BROWNS FERRY NUCLEAR PLANT - IMPROVED TECHNICAL SPECIFICATIONS SECTION 3.8 LIST OF REVISED PAGES

## BROWNS FERRY NUCLEAR PLANT - IMPROVED TECHNICAL SPECIFICATIONS SECTION 3.8 LIST OF REVISED PAGES

AC Sources - Operating 3.8.1

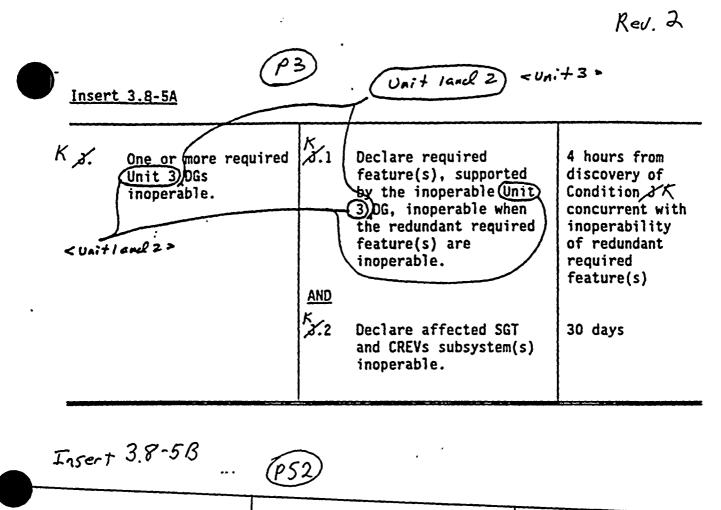
Only applicable when one 4.16 kV shutdown board is affected.

G. One required offsite circuit inoperable.

AC Sources - Shutdown 3.8.2

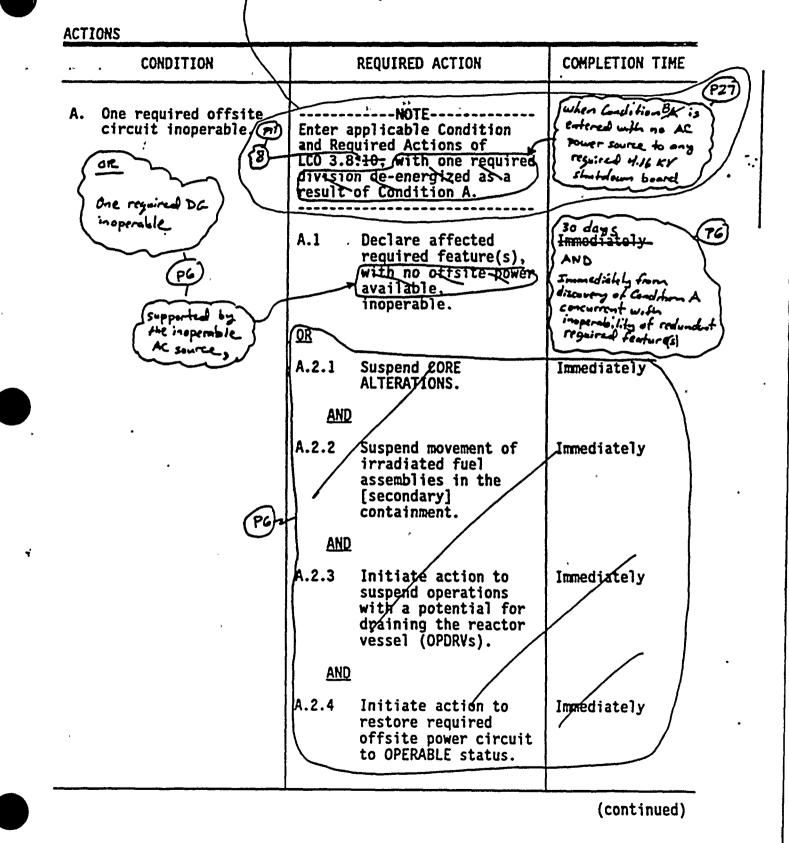
(move note to position innediately preceeding Required Action 3.8.2.0.1 on next Page
